SUNDRY NOTICES AND REPORTS ON WELLS

☐ Oil Well ☒ Gas Well ☐ Other7. If Unit of CA/Agreement, Name and/or No.
891005247E8. Well Name and No.
COTTON DRAW UNIT 76

PROPOSED PLUG & ABANDONMENT

Permanent Abandonment of Federal Wells
Conditions of Approval (LPC Habitat)

CURRENT WELLBORE SCHEMAT

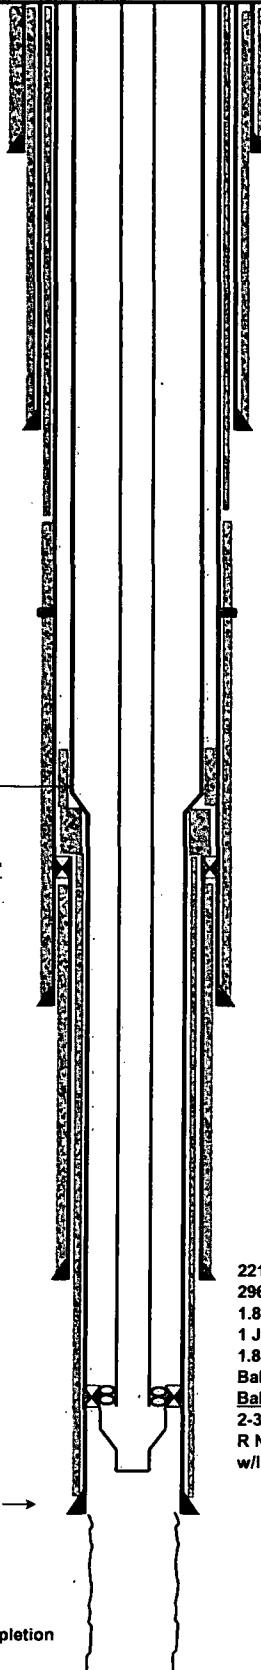
- MIRU. POOH w/ 2-7/8" production tubing from 16,310'.
- Set CIBP @ 16,295'. Spot 25 sx (200') CI H from 16,095' to 16,295'. Tag TOC.
- Spot 55 sx (450') CI H from 14,295' to 14,748'. Tag TOC. (Morrow top @ 14,382', 7 5/8" shoe @ 14,698') ** All Plug 13717-13517 (Straw)*

- Spot 85 sx (280') CI C @ 4,350' to 4,630'. Tag TOC. (Delaware top @ 4,411', 13-3/8" shoe @ 4,578')
- Spot 30 sx (100') CI C @ 3,750' to 3,850'. Tag TOC. (Salt base @ 3,800') *140' Plug*
